MARINE ENVIRONMENT PROTECTION
COMMITTEE
78th session
Agenda item 7

MEPC 78/7/23
15 April 2022
Original: ENGLISH
Pre-session public release:

REDUCTION OF GHG EMISSIONS FROM SHIPS

Comments on document MEPC 78/7/11

Figure 1: trends of the effects of the proposed port time correction factor
Port time correction factor advantages

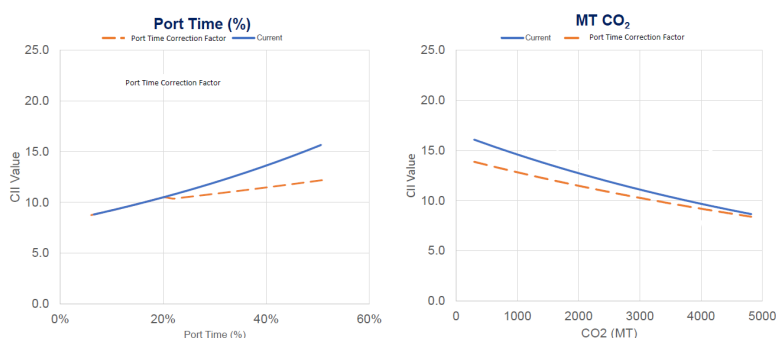
13 The sub-group found that implementation of AF_{PT} mitigated, but did not eliminate, the trend between increasing time in port and increasing attained CII values. Additionally, it was found that the correction factor provided the most benefit to ships emitting the least GHG emissions, while hardly providing any benefit to ships emitting the most GHG emissions. Two charts demonstrating these trends based on the itinerary database follow.

14 The port time correction factor has multiple advantages which support its inclusion in the guidelines. First, as demonstrated by the charts above in figure 1, implementation of the port time correction factor mitigates the perverse incentive to sail further to reduce attained

CII values. This would reduce the impact this measure would have on cruise ships with high port time itineraries which produce fewer absolute emissions. This is accomplished without excluding any emissions for consideration by the CII calculation method.
